Re: Brandywine Subdivision Arm of Crooked Creek Drain

Re: Brandywine Arm to Crooked Creek Regulated Drain Reconstruction
Final Inspection Report

Map Correction-Field Verification

Drain Name: Crooked Creek: Brandywine Arm

Project Name:
Brandywine Arm of Crooked Creek Drain (Pond)
Plan and Profile Sheet

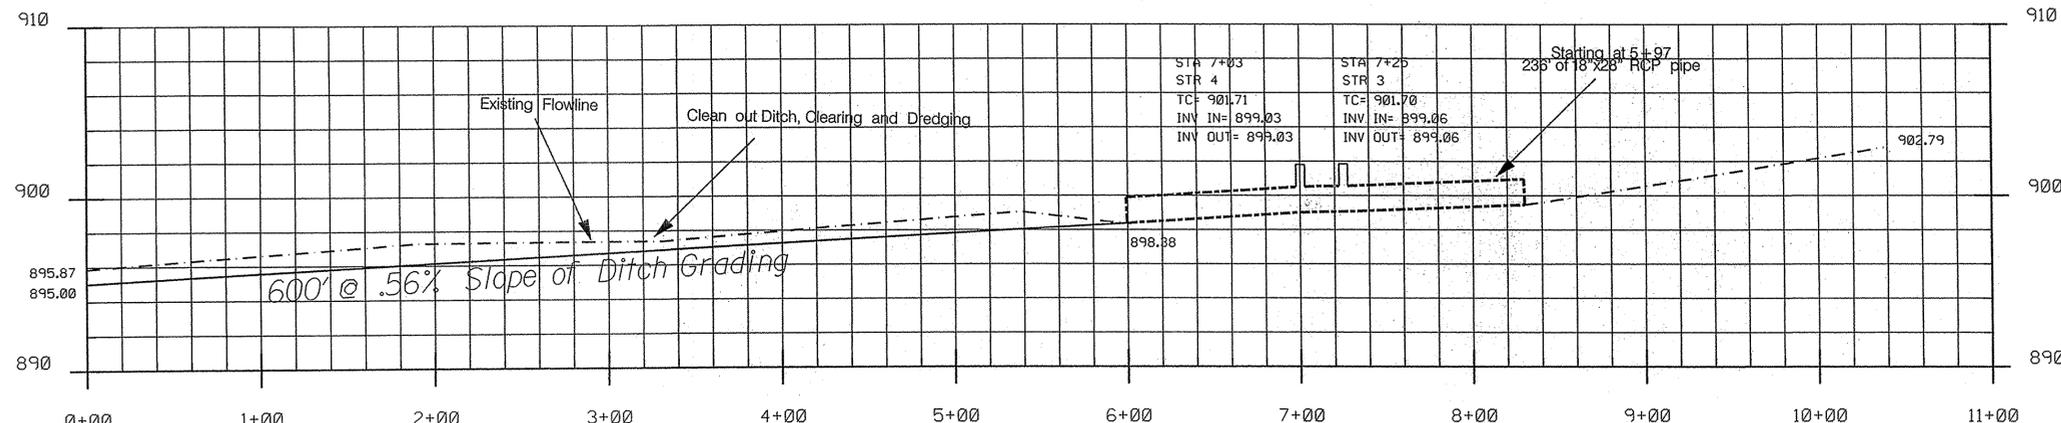
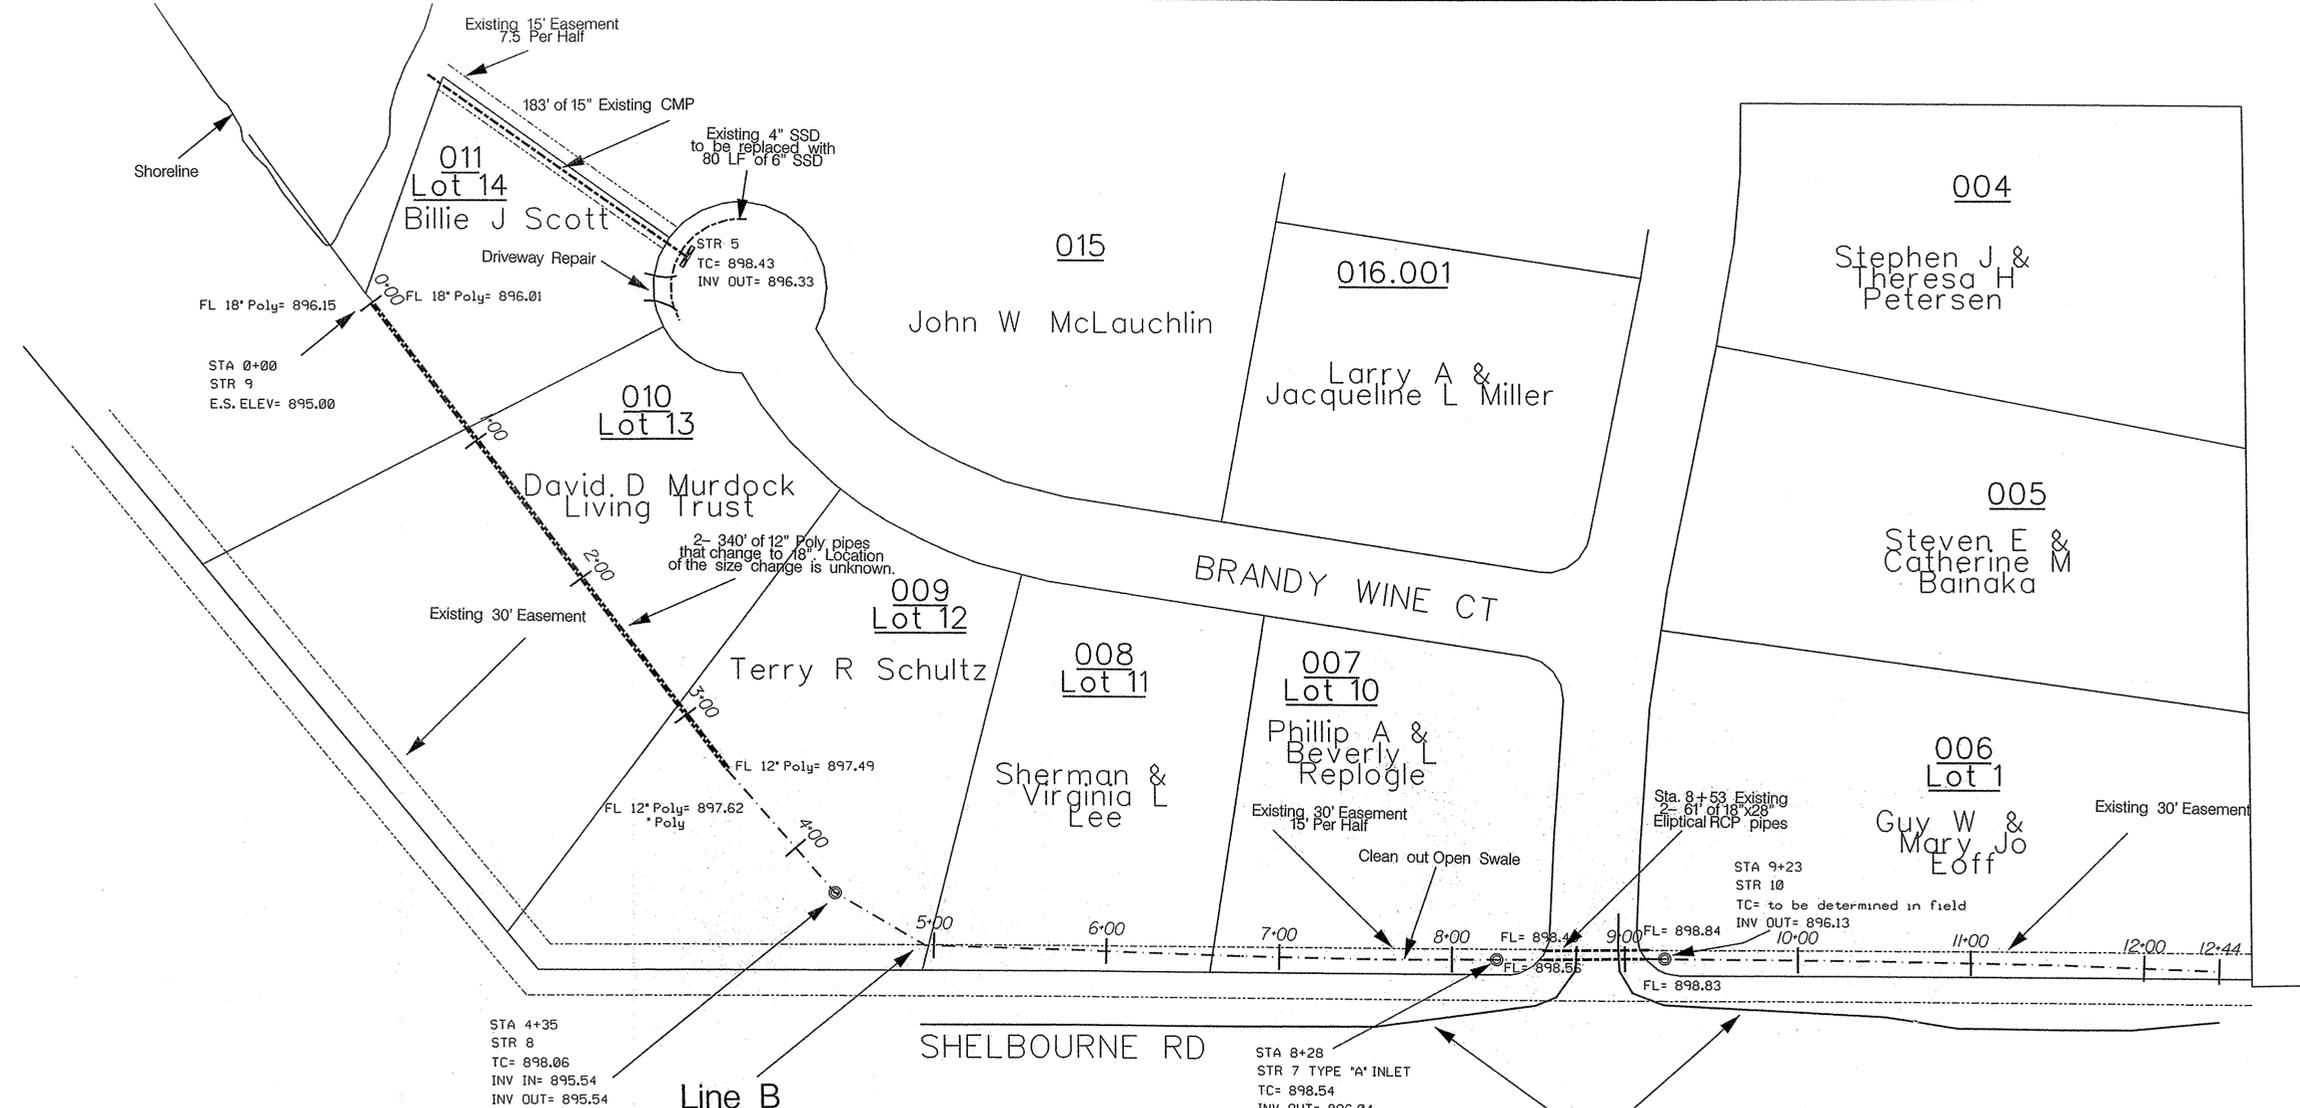
Not Constructed SLM 5-28-09

Project Name: Brandywine Arm of Crooked Creek Drain (Pond)
 Plan and Profile Sheet

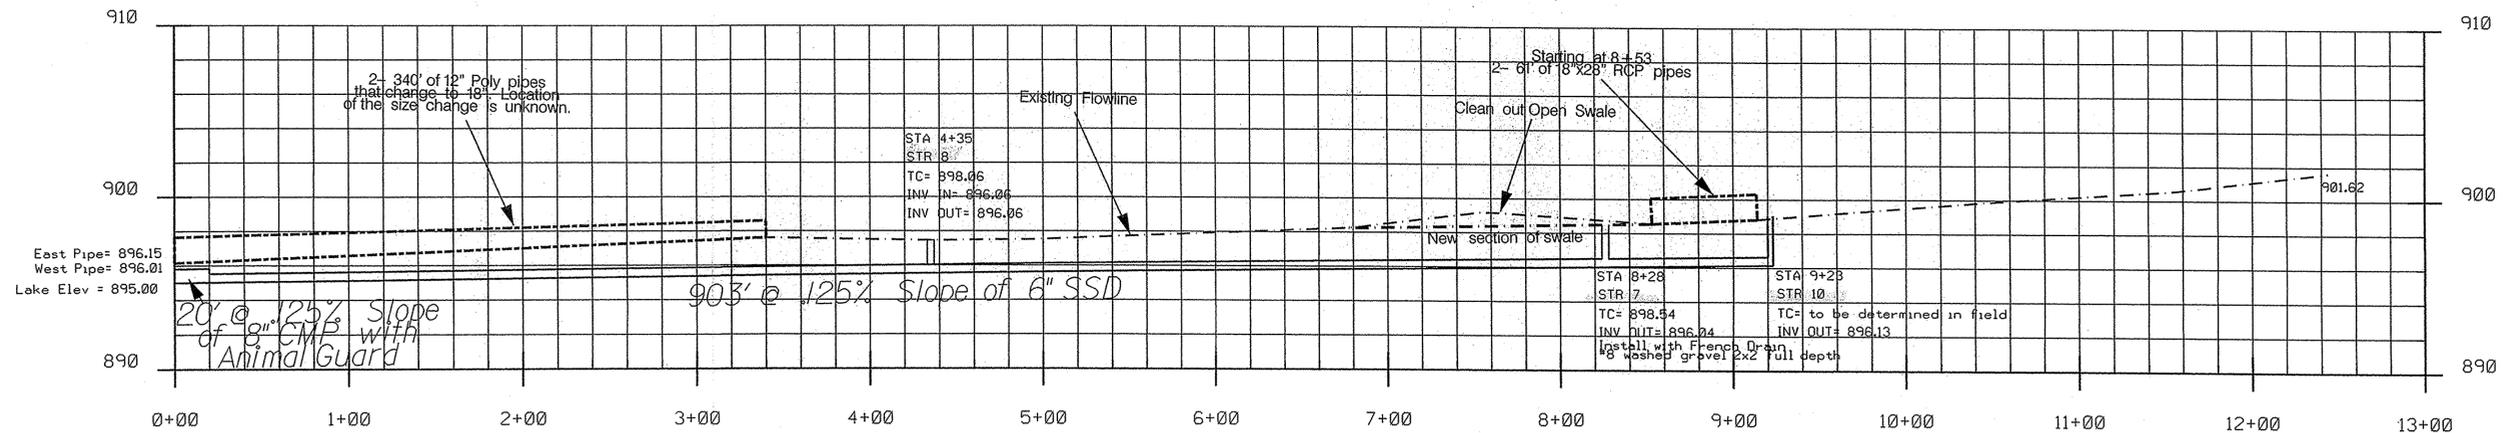
*No T
 Constructed*

SHEET NO.
9 of 15

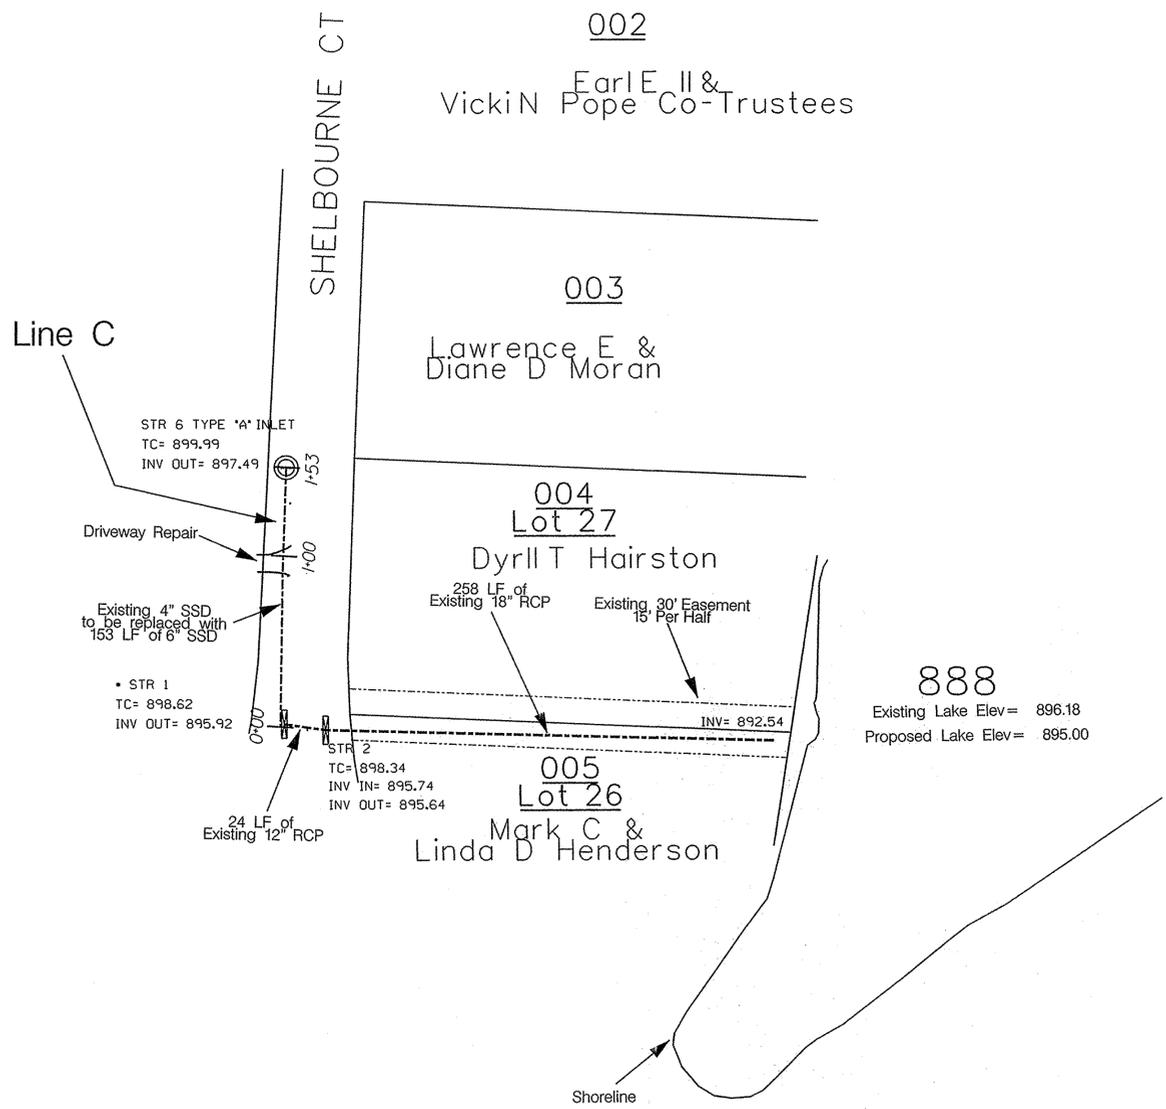
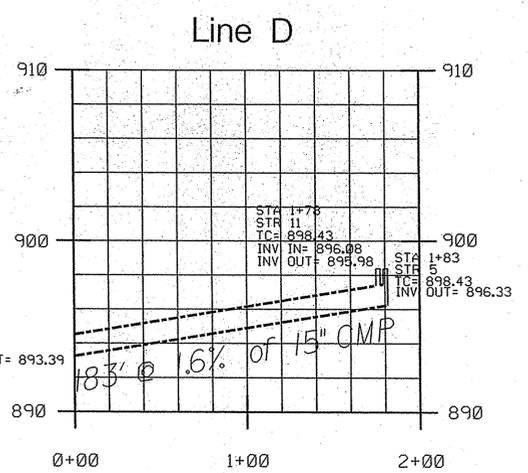
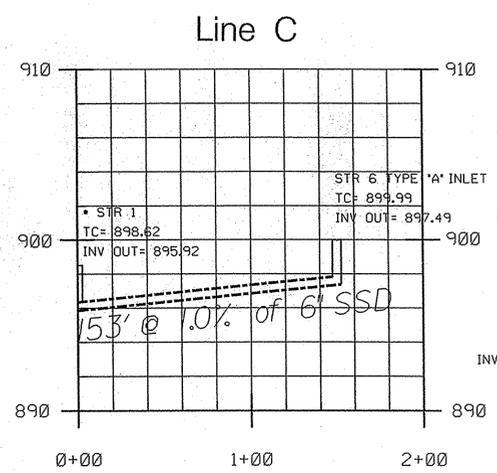
A report was written on Oct. 10, 2006 and approved by the Board on Nov. 27, 2006. This outlined the pipe for the Brandywine Arm of the Crooked Creek Drain. In mapping this arm two changes should be made to the drain. 1) The 6" SSD on Line "C" was never installed and therefore, it was mapped as 153' of 4" SSD. 2) Line "C" also contains 24' of 12" RCP between str. 1 & 2. This was never listed on the original report.

NOT CONSTRUCTED
